## **2.5 Geology, Seismology, and Geotechnical Engineering**

In Section 2.5, "Geology, Seismology, and Geotechnical Engineering," of the SSAR, SERI provided a detailed description of the geological, seismological, and geotechnical engineering properties of the ESP site. In this SER, Section 2.5.1, "Basic Data," describes basic geological and seismological data, especially the data published since 1986 for the area within a 200-mile radius of the ESP site, and presents updated seismic sources. Section 2.5.2, "Vibratory Ground Motion," evaluates the vibratory ground motion for the ESP site and analyzes the safe-shutdown earthquake (SSE) ground motion. Section 2.5.3, "Surface Faulting," describes the potential for surface faulting at or near the surface of the ESP site. Section 2.5.4, "Stability of Subsurface Materials and Foundations," presents the results of site geotechnical investigations and discusses the stability of subsurface materials and foundations. Section 2.5.5, "Stability of Slopes," defers the analyses for slope stability at the site and dam performance, respectively, to the COL stage. Finally, Section 2.5.6, "Embankments and Dams," briefly states that no embankments e

Figure 2.5.5-1 (RAI Figure 2.5.5.1-1)  
Schematic Section Showing Relationships  
Between Loess Bluff Slide and ESP Site

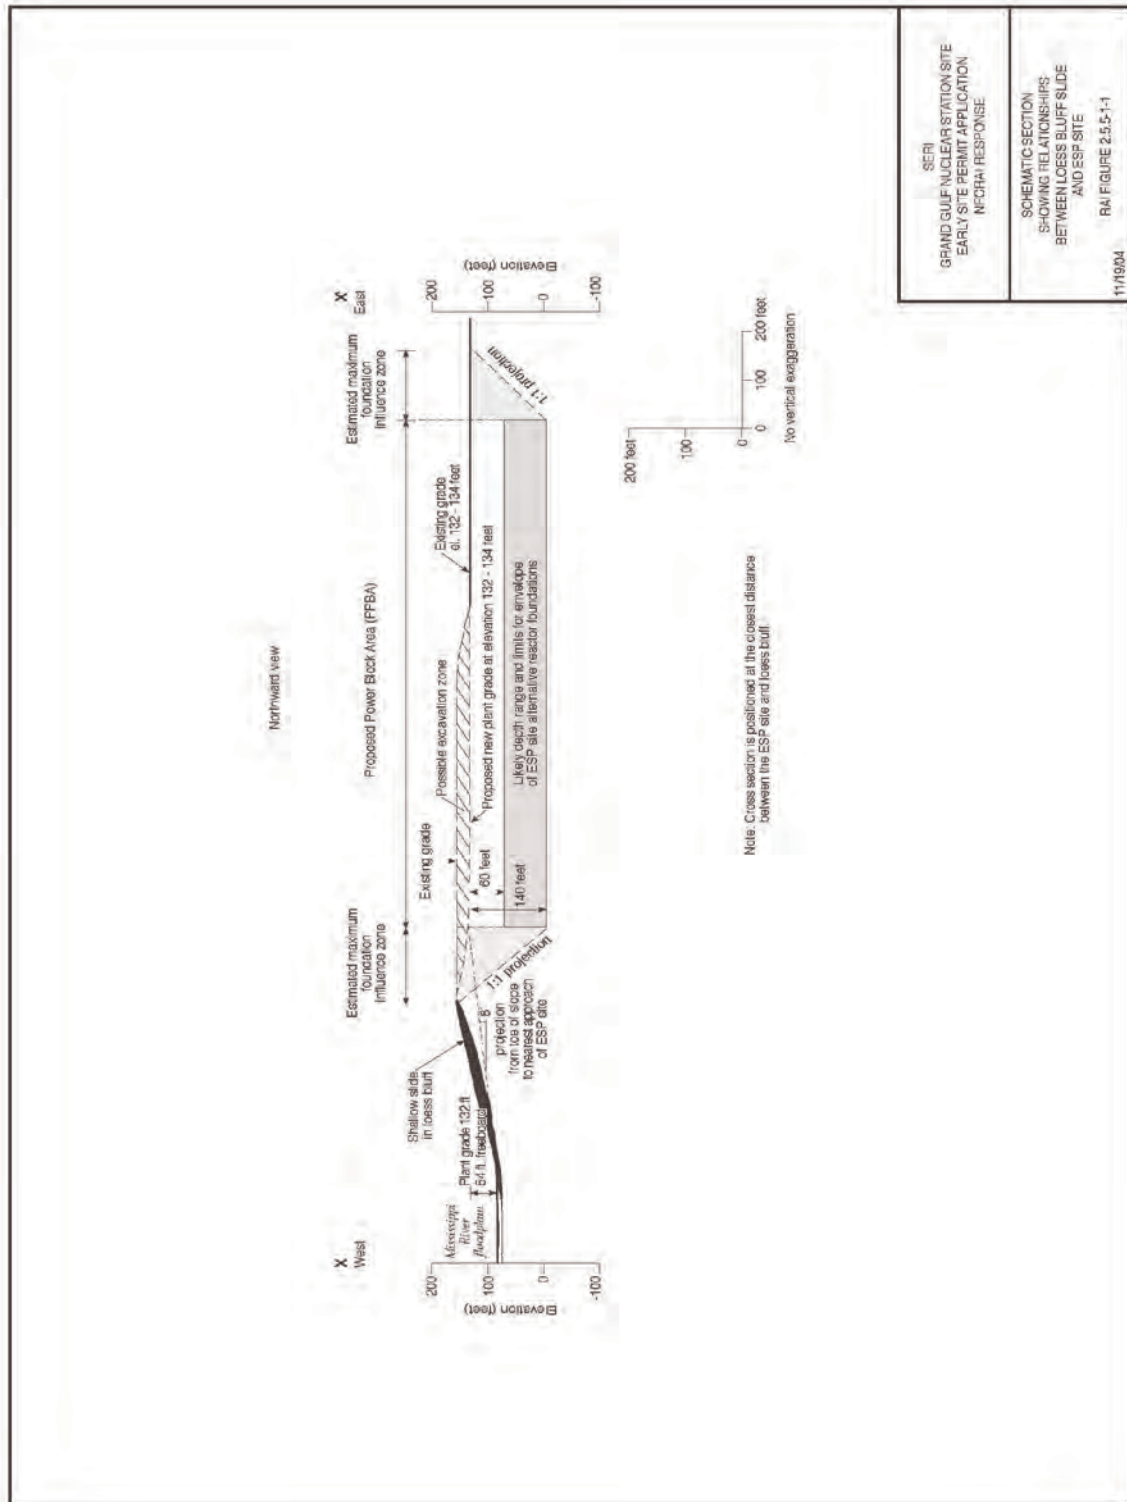
As stated in the SSAR, no plans exist to perform specific analyses to evaluate the stability of deep foundation excavations for the future facilities at the proposed ESP site until the COL phase. In addition, the applicant stated that it did not find any indications of unstable materials underlying the site that should cause unusual stability conditions for excavations and excavation support. In SSAR Section 2.5.5 and Sections 3.3 and 12.5.2 of ER-02, the applicant noted that a 60–70-foot escarpment that may be subjected to surficial slumps and potential creep of the loess soils bounds the west side of the proposed ESP site. The applicant further stated that, since future safety-related facilities would be founded on Upland Alluvium or Old Alluvium encountered below the loess, future movements of the slope should not have any significant impact on these foundations. However, if such facilities are founded close to the scarp, such slump or creep effects could have an impact on lateral loads applied to such deeply founded facilities. In RAI 2.5.5-1, the staff asked the applicant if it had performed any evaluation to indicate the expected behavior of the loess escarpment or the extent to which such movements could occur. In addition, the staff also asked the applicant if the ESP site should have some exclusionary zones along the west-side boundary that would not be susceptible to such potential future slump. In its response, the applicant stated that SSAR Figure 2.5-69 shows the spatial relationships among the PPBA and the loess bluff and the postulated shallow slump in the bluff near the west boundary of the ESP site. The applicant evaluated the potential hazard to the site from slope failure and creep in the loess bluff by examining geologic cross-sections, evaluating embedment depths and positioning of ESP structure foundations, and qualitatively assessing the bluff slope stability in relation to the relative strength of subsurface materials. The applicant further stated that it developed a simplified cross-section to show the geometric relationships between the loess bluff and the site. In this schematic cross-section, the PPBA is set back over 100 feet from the closest approach of the bluff and top of the postulated slump. The maximum foundation influence zone envelope extends to just within the headscarp of the slump area. However, the likely depth range for the prospective reactor foundations required to satisfy minimum embedment and shear wave velocity criteria places the foundation level about 10–80 feet below the elevation of the toe of the bluff slope. The applicant also stated that it is unlikely to develop a failure plane that extends from the toe of the bluff or headscarp of the postulated slump back to the PPBA. A failure plane would have a very gentle inclination of about 8 degrees and would need to intercept the perimeter of the PPBA at least 5–10 feet below plant grade. The applicant believed that such a low-angle failure plane is very unlikely based on an estimated in situ effective friction angle of 33–34 degrees measured by triaxial UC

testing of loess samples. Therefore, the applicant concluded that no kinematically feasible bluff failures could extend back to, or negatively impact, the stability and lateral confinement of prospective reactor foundations within the PPBA. Based on the qualitative stability assessment, the hazard to the ESP site from possible future movements in the loess bluff is very low to none and does not require additional analysis at this ESP stage. The applicant stated that an exclusionary zone between the top of the bluff and the ESP PPBA, therefore, is not necessary.
